1973 Corvette: Service Bulletin: Exhaust Manifold Heat Shielding

73-T-8

Subject: EXHAUST MANIFOLD HEAT SHIELD -
1973 CORVETTE WITH 350 CU. IN.
ENGINE WITH AIR CONDITIONING

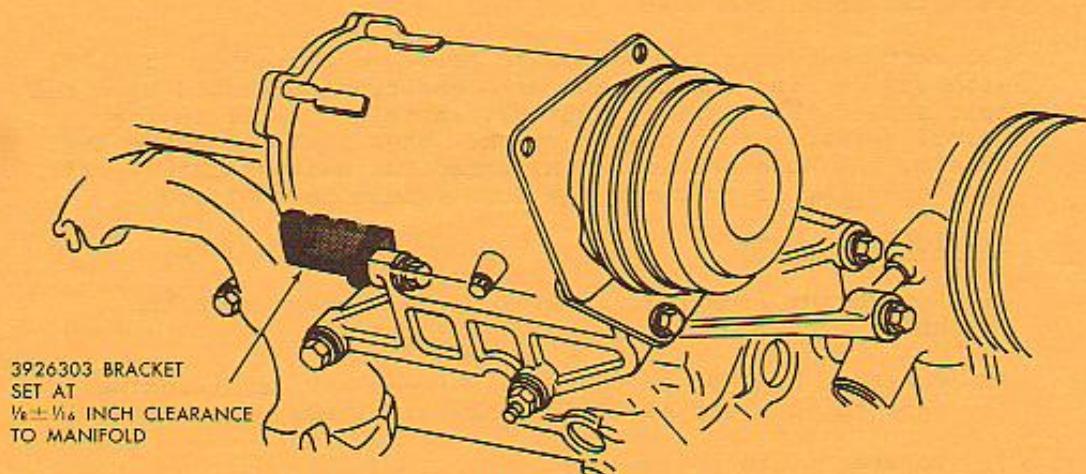
Some early production 1973 Corvettes equipped with 350 cu. in. engines and air conditioning may experience air conditioning hose damage due to close proximity of the exhaust manifold.

Corvettes assembled after September 13, 1972, have a heat shield installed between the hose and the manifold to protect the hose from heat.

For service, Corvettes assembled prior to September 13, 1972, with 350 cu. in. engines and air conditioning should have the heat shield, Part Number 3926303, installed while in for normal service or in dealer stock. When installing the heat shield, the hose should be inspected for heat cracking. If heat cracking is evident, the hose should be replaced.

- 1) Remove nut from rear compressor to bracket mounting bolt.
- 2) Position bracket on bolt and between air conditioning suction hose and manifold as illustrated.
- 3) Torque nut to 25 ft. lbs.
